COMMUNITY BOARD FEEDBACK PACKAGE

COMMUNITY BOARD RECOMMENDATION FORM

10th Avenue Cookshop	
afe Address:	156 10 AVENUE, NEW YO	PRK, NY, 10011
pplication Numb	ber: 20240719010015	
B Review Deadli	ine (on date or next busines	s day): 4/5/2025
idewalk Cafe Set	tup Feedback:	Community Board chooses to WAIVE review
Гhe proposed Site equired 10 foot p	edestrian clear path. To provi	d dimensions: valk obstructions at this location and does provide for the de for the required clear path, the applicant has agreed to chairs and has provided the attached Revised Site Plan.
comments related to	o pedestrian flow (i.e., visbility, sa	rfety , potential crowding):
Comments related to	to potential conflicts with existing	curb use (i.e., planters, bike racks, bus stops):
lease check one of t	the recommendations below, eith	curb use (i.e., planters, bike racks, bus stops): er approval, denial, or approval with modifications relating to
lease check one of t	the recommendations below, eith	A80337

SUPERSEDED

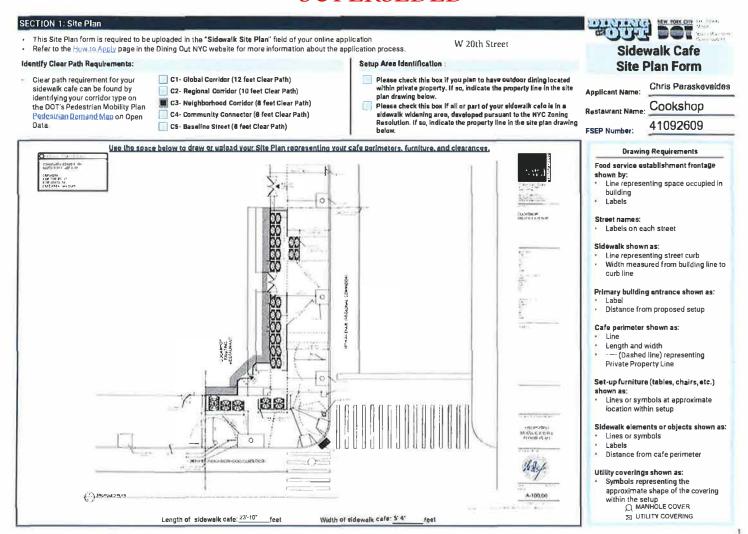
Community Boar Community Boar Recommended mod To provide for the reflect all sidewal reduced according	the recommendations below, eithers: Independent of the recommends approval with mode diffications (only if approved with mode approved with the required 10 foot pedestrian lik obstructions and that the tax	er approval, denial, or approval with modifications relating to Community Board recommends denial
Community Boar Community Boar Recommended mod To provide for the reflect all sidewal reduced according Site Plan.	the recommendations below, either in the recommends approval or difference of the recommends approval w/ mode diffications (only if approved w/ mode in the required 10 foot pedestrian lik obstructions and that the taingly. Applicant has agreed to the recommendations of the recommendations and that the taingly.	er approval, denial, or approval with modifications relating to Community Board recommends denial ifications odifications): clear path, MCB4 requests that the proposed Site Plan bles and chairs in the sidewalk cafe be rearranged and
